Technical Bulletin

PJ 84 Improved Marking Possibilities

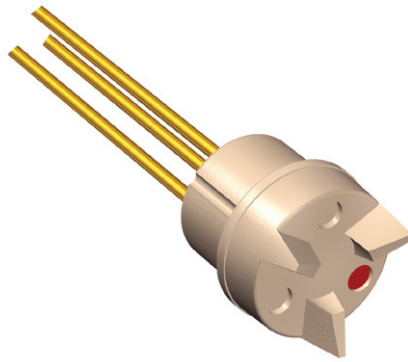
To improve the color coding possibilities of the PJ 84 knob, Sonion has introduced a new Knob No. 2.

The mechanical dimensions are identical to Knob No. 1. However, as seen on the above illustration, this knob has three small cavities for color dot marking, located in each of the three areas which divide the knob.

These indentations allow for a blue/red color coding of a higher and more consistent quality compared to the previous Knob No. 1.

For this reason, we have also decided to discontinue Knob No. 1.

For current users of the PJ 84 with Knob No. 1, you will receive a new Sonion part number next time you order the PJ 84.
